Agenda Item # 6

SUB-003891-2026

Ace Hardware and Spirits Subdivision

- Subdivision approval to create one (1) legal lot of record from three (3) existing legal lots of record.

SUBDIVISION SITE PLAN

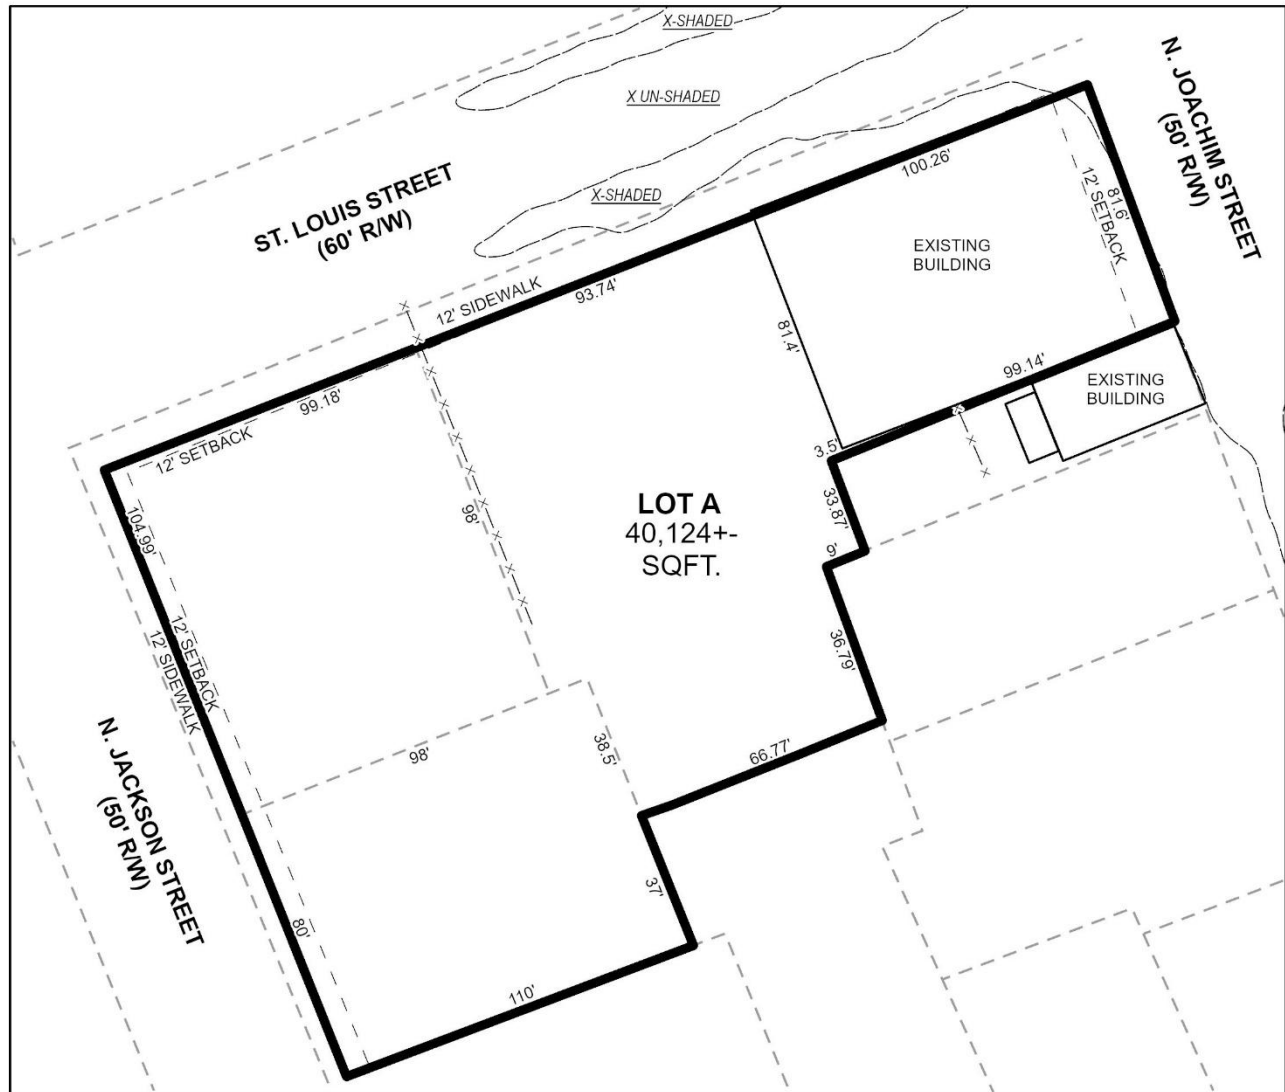
The proposed lot has frontage along North Joachim Street and North Jackson Street, major collector streets classified as "B Streets" within the DDD, and require 50-foot-wide rights-of-way. The lot also fronts, St. Louis Street, a major collector street classified as an "A Street" within the DDD, and requires a 50-foot-wide right-of-way. The preliminary plat depicts sufficient rights-of-way, making additional dedication unnecessary.

As a corner lot, Section 9.F.3.(b)(3) of the Subdivision Regulations allows the provision of additional corner or curb radii to be determined by the City Engineer, Traffic Engineering Director, and, where applicable, the Alabama Department of Transportation (ALDOT). The preliminary plat does not depict dedication of a corner radius.

Section 9.F.4.(a)(1) of the Subdivision Regulations requires the designation of a primary street frontage for properties within the DDD that abut more than one (1) street. When a lot has frontage along an "A Street," the primary frontage is required to be along that street. As such, a note identifying St. Louis Street as the lot's primary frontage should be placed on the Final Plat.

Section 9.F.4.(b) of the Subdivision Regulations and Appendix A, Section 9.A.2. of the UDC establishes a minimum lot width of 14-feet and a maximum lot width of 180-feet along the primary frontage for properties within the T-5.1 sub-district of the DDD. The proposed lot, if approved, will be 293.3-feet wide, making a waiver of Section 9.F.4.(b) of the Subdivision Regulations necessary.

While no minimum lot area is required in this zoning district, Section 5.A.2.(e)(3) of the Subdivision Regulations requires lot area to be labeled in both square feet and acres on the Final Plat. The preliminary plat provides the lot area in both square feet and acres. The Final Plat should retain this information, adjusted for any required dedication.

Table A-9.1 in Appendix A of the UDC allows primary buildings in the T-5.1 sub-district to be set back a maximum of 12-feet from the primary frontage, with unrestricted setbacks for outbuildings provided applicable fire-rating requirements are met. The preliminary plat submitted depicts the twelve-foot (12') maximum setback along all street frontages, and should be retained on the Final Plat, if approved.

Appendix A, Section 9.C.3.(e)(3) of the UDC limits properties within the T-5.1 sub-district to one (1) curb cut per secondary street frontage. As such, typically the site would be required to reduce the number of curb cuts in order to comply, however as mentioned previously, the site was granted a Variance to allow a curb cut to the site's primary frontage (St. Louis Street) and two (2) curb cuts to a secondary frontage (North Jackson Street). As such, either a note stating the Variance allowances for curb cuts should be placed on the Final Plat (if recorded prior to the Variance expiration in April 2027) or stating the standard curb cut allowances of the DDD.

Appendix A, Section 9.C.3.(c)(2) of the UDC limits driveway widths in the T-5.1 sub-district to a maximum of 25-feet within the site's frontage. A note reflecting this requirement should be placed on the Final Plat, if approved.

If the Subdivision request is considered for approval, a waiver of Section 9.F.4.(b) (lot width) of the Subdivision Regulations will be required and the following conditions could apply:

1. Retention of the right-of-way labels along all street frontages;
2. If required by the City Engineer, Traffic Engineering Director, and/or ALDOT, the Final Plat should be revised to illustrate dedication of the corner radius at the intersection of North Joachim Street and St. Louis Street;

3. If required by the City Engineer, Traffic Engineering Director, and/or ALDOT, the Final Plat should be revised to illustrate dedication of the corner radius at the intersection of North Jackson Street and St. Louis Street;

4. Provision of a note on the Final Plat stating that the site's primary frontage is designated along St. Louis Street;
5. Revision of the lot's size in both square feet and acres, in compliance with Section 5.A.2.(3)(3) of the Subdivision Regulations, adjusted for dedication, if required;

6. Retention of the Final Plat to illustrate the maximum allowable building setback of twelve feet (12') along all street frontages;
7. Either provision of a note on the Final Plat stating that the site is limited to two (2) curb cuts to North Jackson Street and one (1) curb cut to St. Louis Street (if the October 2026 Variance approval is still active) or provision of a note stating that the site is limited to a single curb cut to its secondary frontage;

8. Provision of a note on the Final Plat stating that driveway widths are limited to a maximum of 25 feet within the site's frontage, in accordance with Appendix A, Section 9.C.3.(c)(2) of the Unified Development Code;
